Form 3160-5

| (June 2015) DEF | PARTMENT OF THE I | | 2018 | OMB No. 1004-0137 Expires: January 31, 2018 |
|--|---|--|--|---|
| ☐ Oil Well ☐ Gas Well ☐ Other | | | | 8. Well Name and No. HUGGINS DRAW FED COM #2 |

RE: Written Order 18RH21W Huggins Draw Fed Com #2 API # 30-005-61262 Section 31, T5S, R24E

Huggins Draw Fed Com 2 30-005-61262 Jalapeno Corporation December 06, 2018 Conditions of Approval

Schematic after P&A

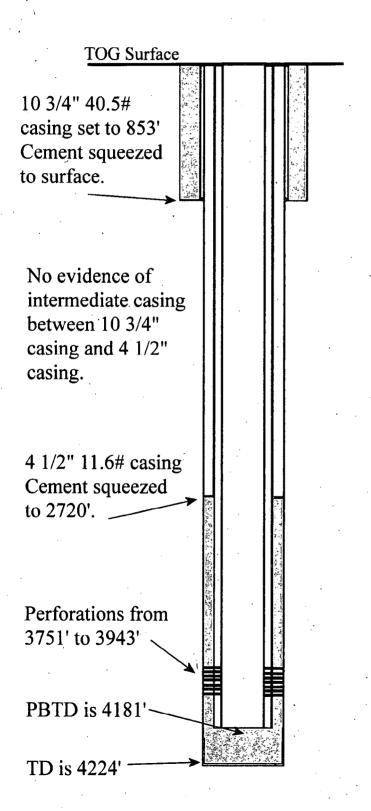
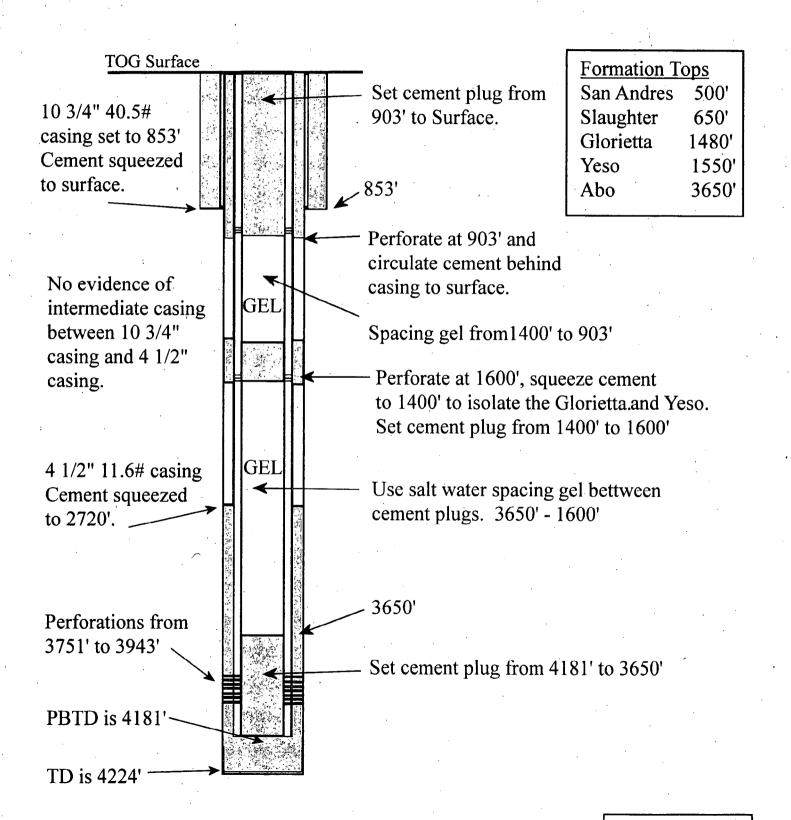
| (June 2015) DEF | PARTMENT OF THE I | | 2018 | OMB No. 1004-0137 Expires: January 31, 2018 |
|--|---|--|--|---|
| 1. CEMENT FROM 4181' TO SETILL HOLE WITH SALT WAT 3. PERFORATE AT 1600' AND 4. CEMENT FROM 1600' TO 15. FILL HOLE WITH SPACING 6. PERFORATE CASING AT 97. CEMENT FROM 903' TO SETILL HOLE MARK | TER SPACING GEL FROM SQEEZE CEMENT BEHI (400', WOC & TAG. GEL FROM 1400' TO BE (103' AND SQEEZE CEME) JRFACE, WOC. | M 3650' TO 1600'. IND CASING TO 1400' TO IS ELOW 903'. NT TO SURFACE. S | EE AT | Accepted for record • NMOCD DRIETTA AND YESO FORMATIONS. TACHED FOR TIONS OF APPROVAL |

- 1. Operator shall set a Class C plug from 4,181'-3,557' to seal the producing formation and the Abo Formation. WOC and Tag as proposed.
- 2. Operator perf and squeeze at 1,600' as proposed and place a balanced Class C plug from 1,600'-1,400' to isolate the Glorietta Formation. WOC and tag as proposed.
- 3. Operator perf and squeeze at 903' as proposed and place a balanced Class C plug from 903'-surface.
- 4. See Attached for general plugging stipulations.
